SUBJECT: Informs that end connections of turbine bldg structural member 25 will resist seismic member forces. No mods will be made for Open Issue 2, in response to SEP Topics III-6 & III-11, seismic design considerations.

Subject: SEP Topics III-6 and III-11, "Seismic Design Considerations"
R.E. Ginna Nuclear Power Plant
Docket No. 50-244

SUBJECT RQ&E GINNA STATION
TURBINE BLDG. BRACING EVALUATION

TYPICAL CONNECTION DETAIL PER REFERENCED DETAIL DRAWING.

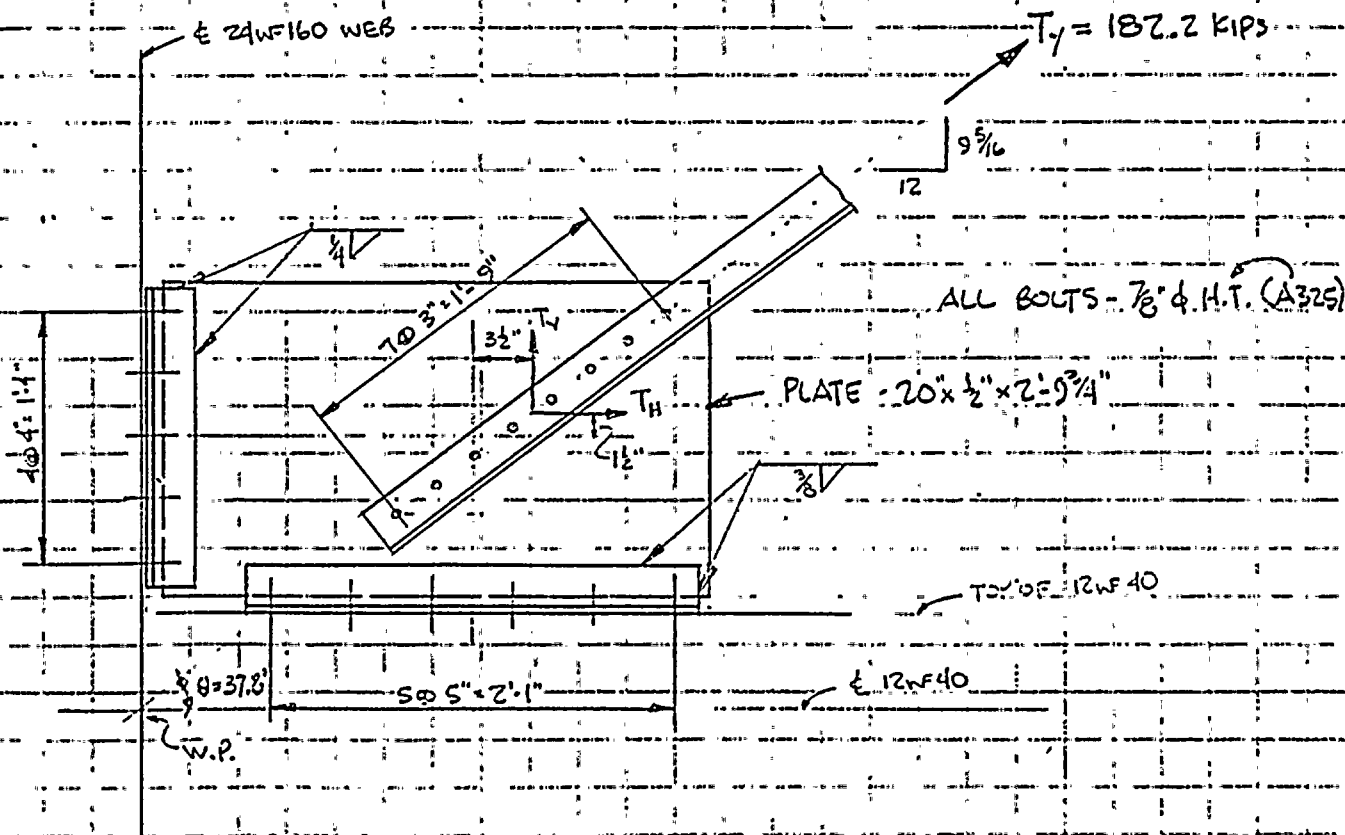
1) CHECK BRACING MEMBER TO GUSSET PLATE BOLTS

→ SAY BEARING TYPE CONNECTION - THREADS IN SHEAR PLANE

FROM AISC 8th EDITION $V_{allow}/\phi_{at} = 25.3 \text{ kips (FOR DOUBLE SHEAR)}$

SSS $T_{allow} = 3 \times 25.3 \times 1.6 = 323.8 \text{ kips} > 182.2 \text{ kips} \quad (ok)$

NOTE: ASSUME THAT CONNECTION SLIPS FROM A FRICTION TYPE CONNECTION TO A BEARING TYPE CONNECTION.

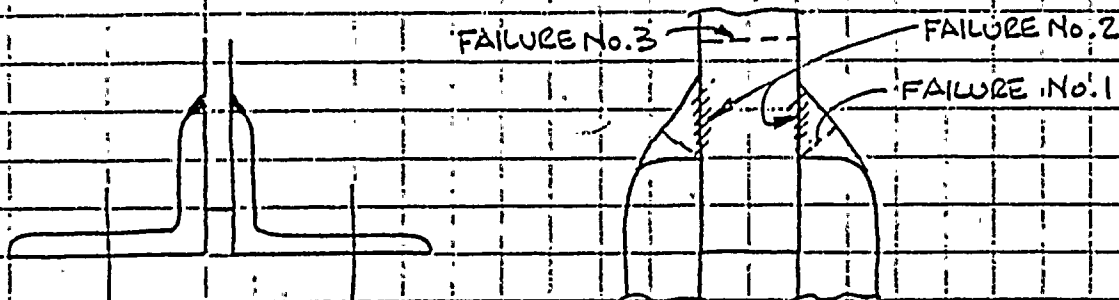
SAY HORIZ. ANGLES RESIST HORIZONTAL LOAD

$$\text{FORCE/IN. OF WELD} = 144 / 32 \times 2 \text{ WELDS} = 2.25 \text{ K/in}$$

$$\text{SSE ALLOW FORCE/IN. OF WELD} = .707 \times \left(\frac{3}{8}\right) \times 18 \text{ ksi} \times 1.6 = 7.63 \text{ KIPS/in} \therefore \text{WELD SHEAR CAPACITY (OK)}$$

$$\left(\frac{\text{AISC 8th Ed}}{\text{PS 5-25}}\right) \text{SSE ALLOW FORCE/IN. OF BASE METAL} = \frac{3}{8} \times (.4 \times 36) \times 1.6 = 8.64 \text{ K/in} \therefore \text{BASE METAL FORCE (OK)}$$

$$\text{FORCE/IN. OF PLATE} = 144 / 33.75 = 4.26 \text{ K/in}$$

$$\text{SSE ALLOW FORCE/IN. PLATE} = .5 \times (.4 \times 36) \times 1.6 = 11.5 \text{ K/in} \therefore \text{PLATE (OK)}$$

SAY VERTICAL ANGLES RESIST VERTICAL LOAD

$$\text{FORCE/IN. OF WELD} = 112 / 23 \times 2 \text{ WELDS} = 2.43 \text{ K/in}$$

$$\text{SSE ALLOW FORCE/IN. OF WELD} = .707 \left(\frac{1}{4}\right) \times 18 \text{ ksi} \times 1.6 = 5.09 \text{ K/in} \therefore \text{WELD SHEAR CAPACITY (OK)}$$

$$\text{SSE ALLOW FORCE/IN. OF BASE METAL} = \frac{1}{4} \times (.4 \times 36) \times 1.6 = 5.76 \text{ K/in} \therefore \text{BASE METAL FORCE (OK)}$$

$$\text{FORCE/IN. OF GUSSET PLATE} = \frac{112}{17} = 6.59 \text{ K/in} < 11.5 \text{ K/in} \therefore \text{PLATE (OK)}$$

\therefore ALL WELDED COMPONENTS ARE ACCEPTABLE
